1. Applicant hereby submits Amendment No. 3 to Change Request No. 25 supplying additional information requested by Division of Reactor Licensing.

SAXTON NUCLEAR EXPERIMENTAL CORPORATION

The following information pertaining to the system safety valve anti-simmer devices is supplied to clarify information previously submitted in Amendment No. 1 to Change Request No. 25:

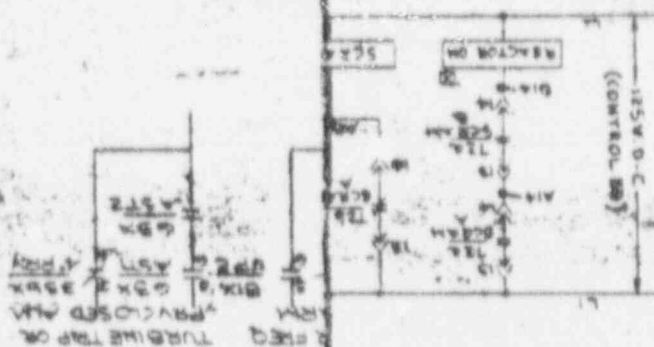
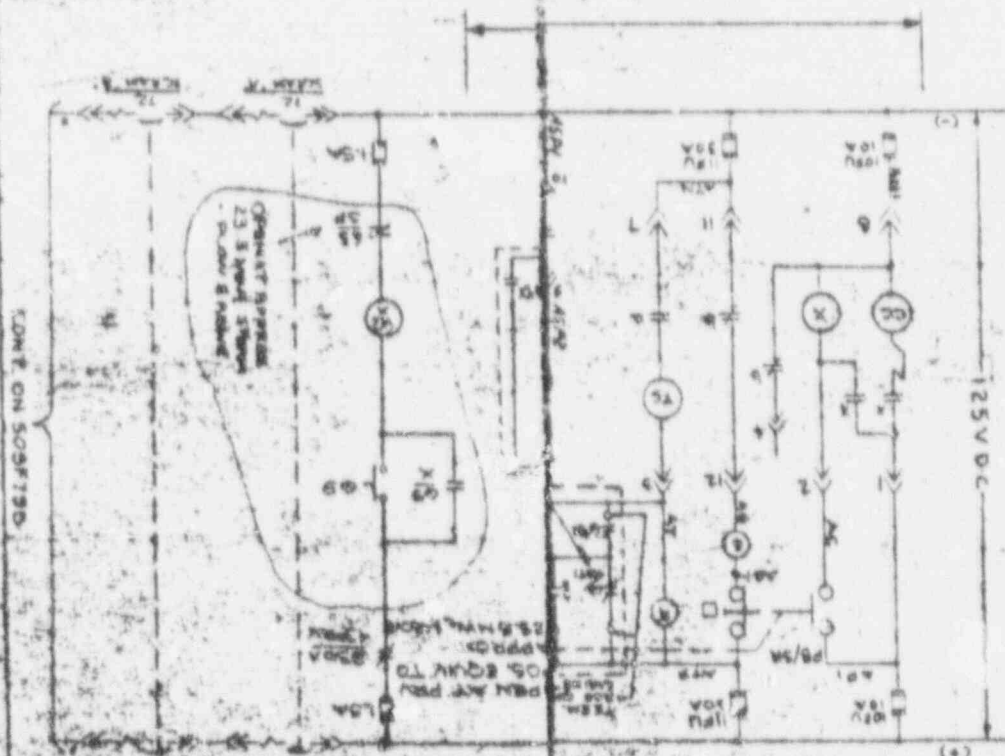
Question II. A.5. - How will the system be tested? How often will the system be retested?

Initially, each safety valve will be individually tested at actual operating conditions to verify the function of the control circuit to the anti-simmer device and to verify that the device does not impede the popping action of the safety valve.

The control circuits only, will be retested once every six months to verify functional performance.
